Re: Response to Information Request

Development Application seeking a Development Permit for Material Change of Use – Place of Worship (Extension to Church) on land described as Lot 29 on SP181745 and located at 13 Mount Kulburn Drive, Jensen

Information Request Planning Act 2016

Proposal: Place of Worship - Extension to Church **Street address:** 13 Mount Kulburn Drive JENSEN QLD 4818

SITE PLAN - PROPOSED

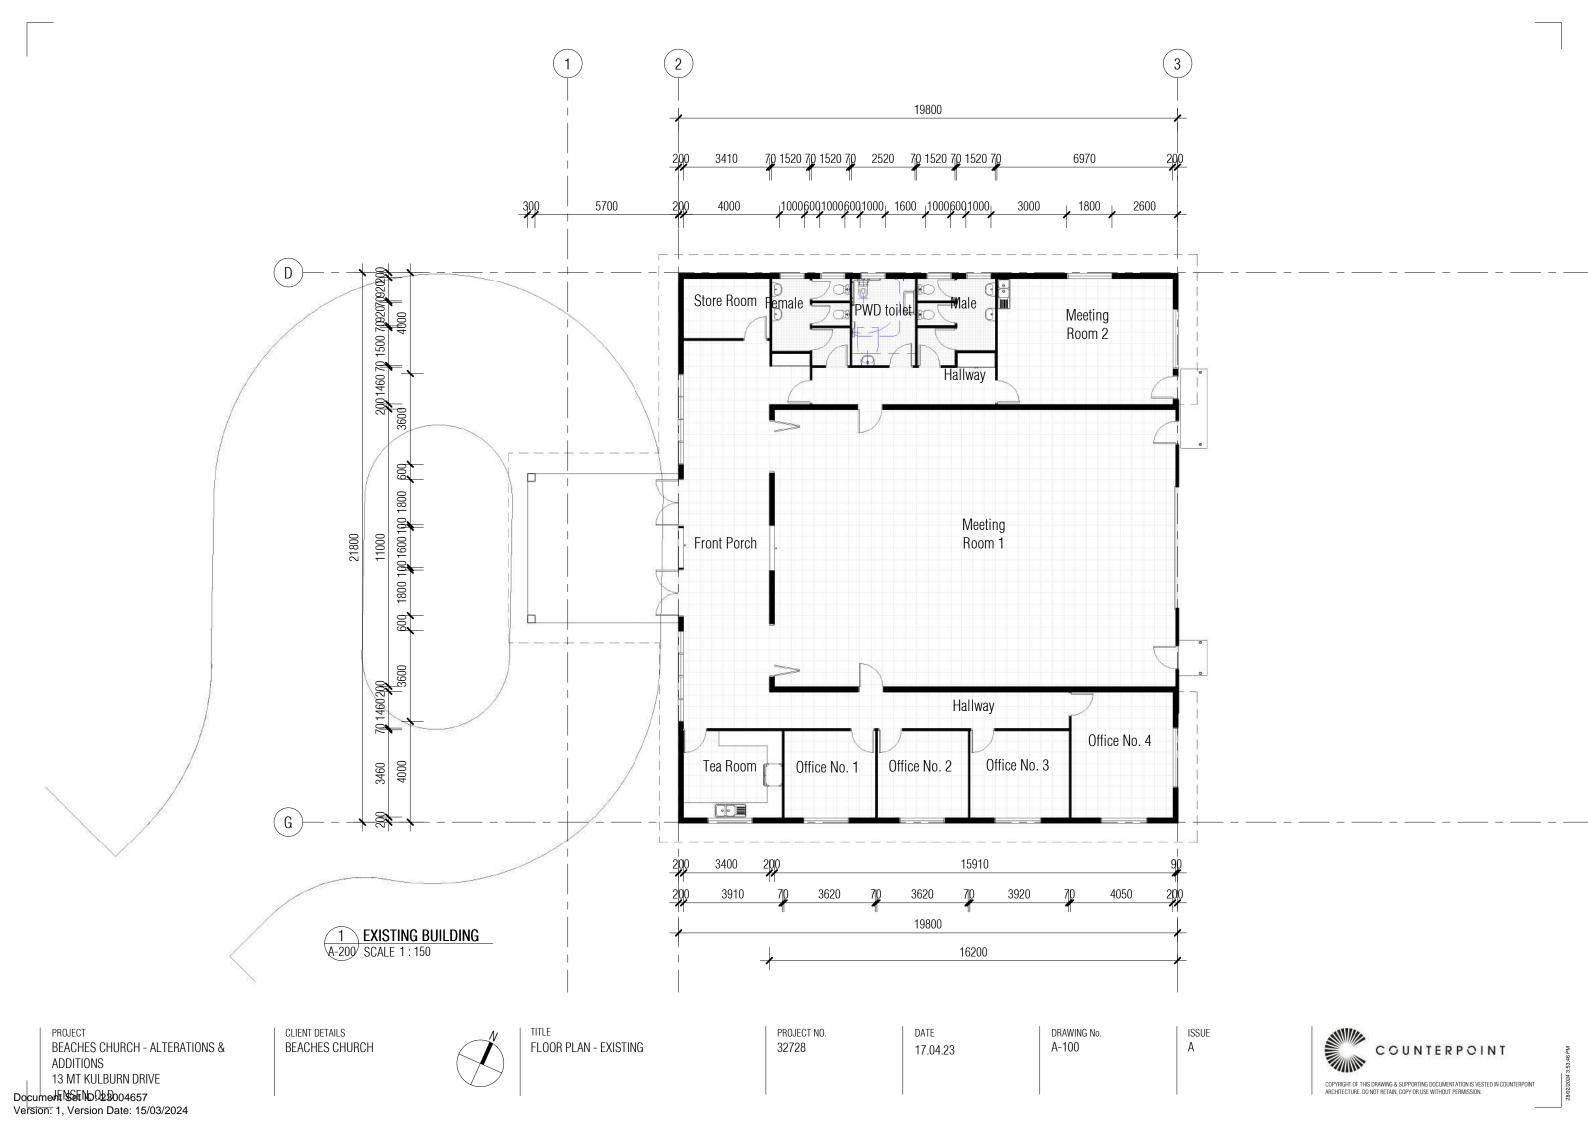
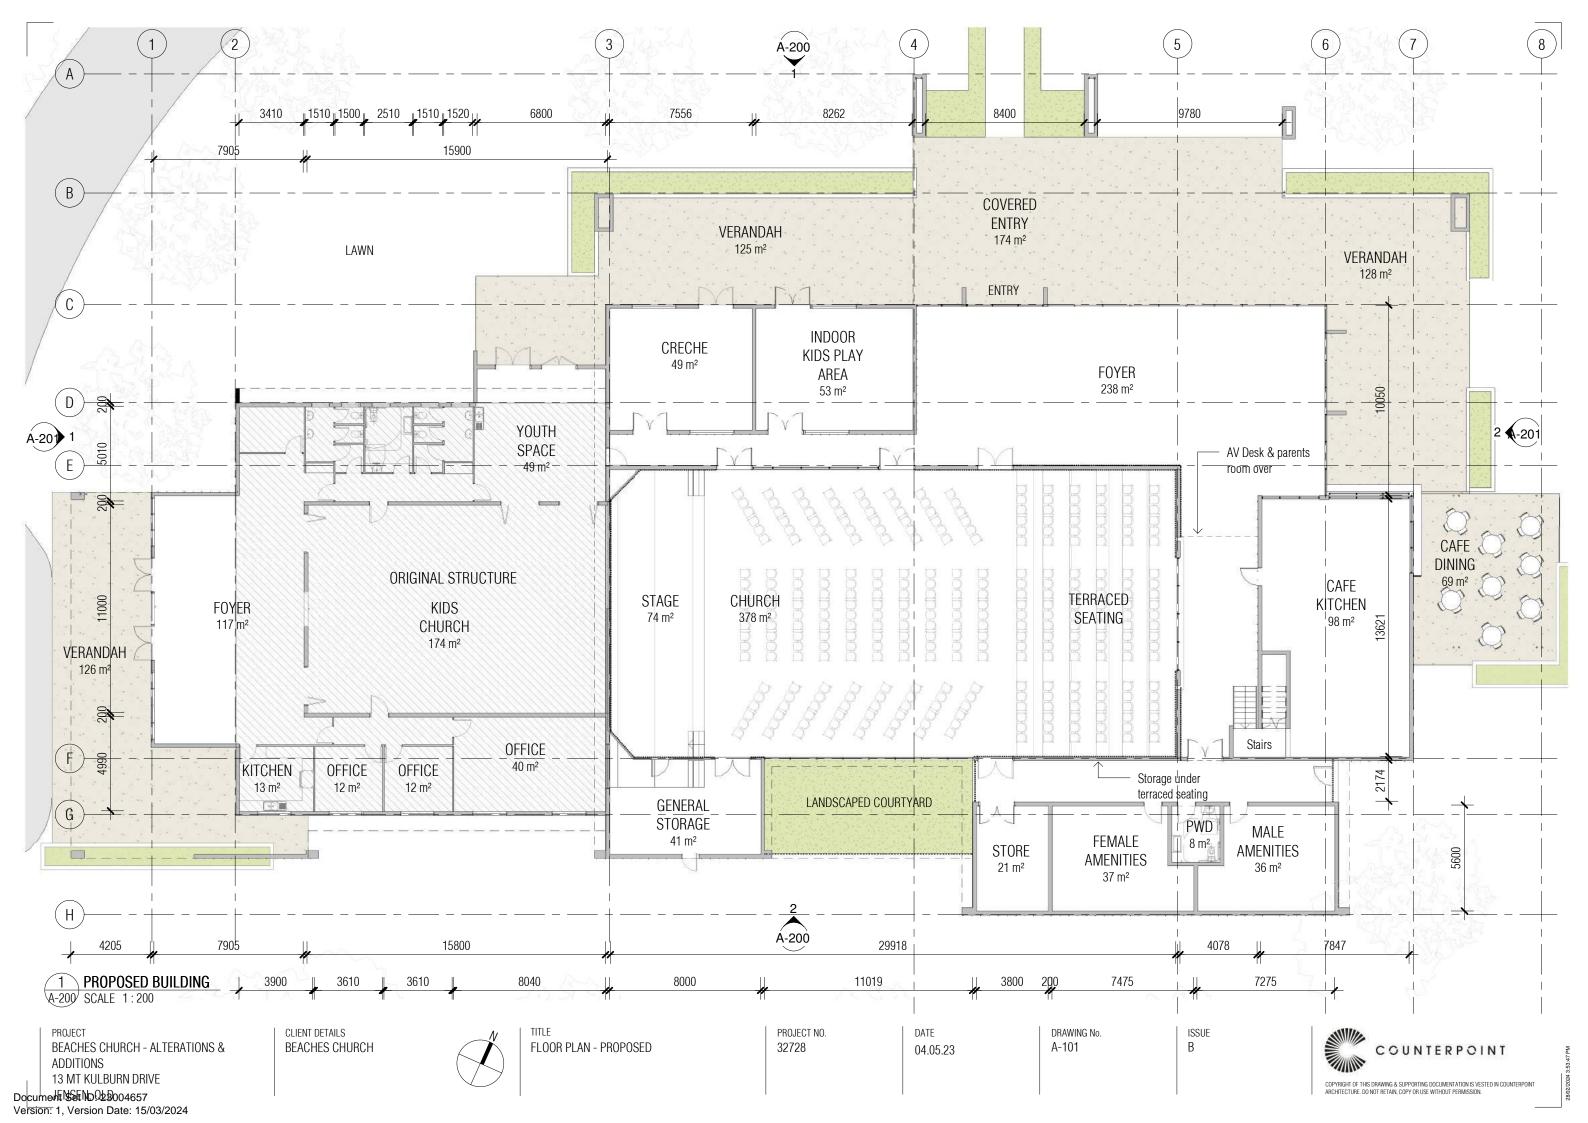
The applicant is requested to provide amended plans detailing line marked set-down and pick-up facilities for the development.

The applicant is requested to provide amended plans detailing on-site loading, unloading and refuse collection areas for the development.

In response to this item, Counterpoint Architecture have included detail of the line marking/ traffic arrangement proposed at the renovated building entrance in the amended set of plans provided at **Attachment 2**.

In response to this item, Counterpoint Architecture have included detail the proposed refuse storage area in the amended set of plans provided at

Table 1 – Response to Information Request				
Item	Response			
	Attachment 2 . The refuse storage area is proposed adjacent the car parking area and will be in an appropriately screened enclosure to ensure the amenity of the site is maintained.

Figure 6: Proposed Master Plan (Source: Counterpoint)

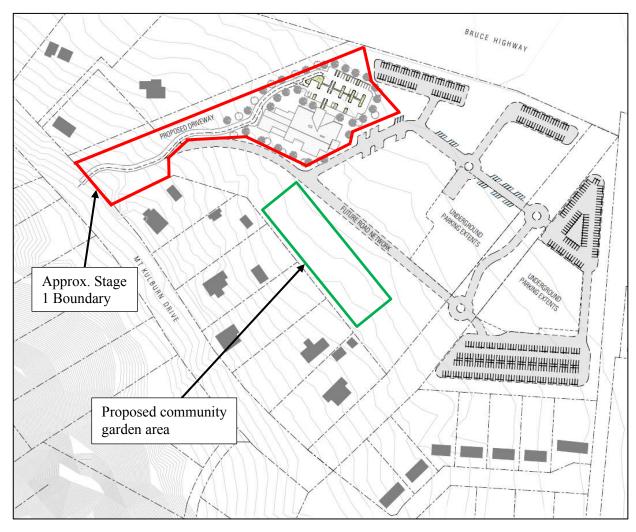
The applicant is requested to provide amended plans clearly showing each stage of the development including proposed amenities as well as the master plan including all stages associated with this application.

The Site Plan - Stage 1 to 4 is missing Stage 3 and does not include the proposed works and the Site Plan - Master Plan does not show the stages or proposed works.

The applicant is advised that the Master plan will enable Council to confirm the loading expected for the proposed development aligns with the Engineering Services Report.

Item 5 Amended Plans for Masterplan	This item requested amended plans clearly showing the staging of the development. We understand there was uncertainty regarding the proposed staging arrangement, including the extent of works in Stage 1 and Stage 2, as well as the future development on site.			
	In response to this item, Counterpoint Architecture have simplified the staging arrangement in the amended set of plans, particularly drawing A-110 – Staging Diagrams – Revision C provided at Attachment 2 . It has also been clarified that the remainder of the subject site is allocated for future development and is not subject to this development application.

Figure 9: Proposed Sewer Alignment with Approximate Invert Levels

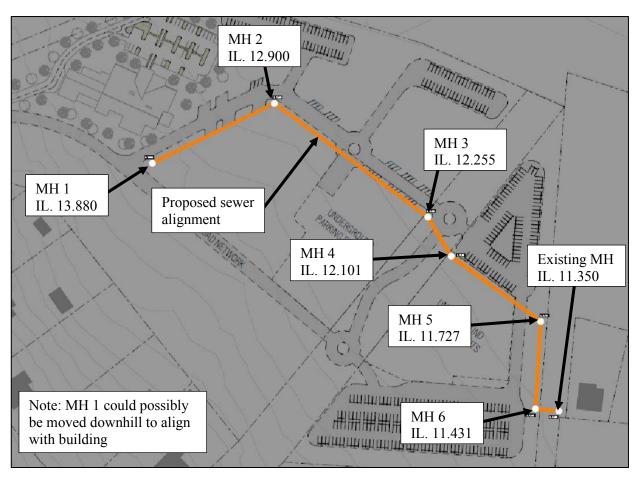
The applicant is requested to provide a plan that clearly identifies the ultimate development that will require sewer connection to the proposed 150 diameter sewer line.

Refer to Figure 9 for the proposed sewer alignment. The proposed sewer line follows the proposed future internal road network and should allow future adjoining buildings to be connected.

The sewer will be able to take the extension amenities and kitchen however the existing kitchen and amenities do not meet the minimum fall outlined in the plumbing code. This is to be confirmed during the detailed design phase.
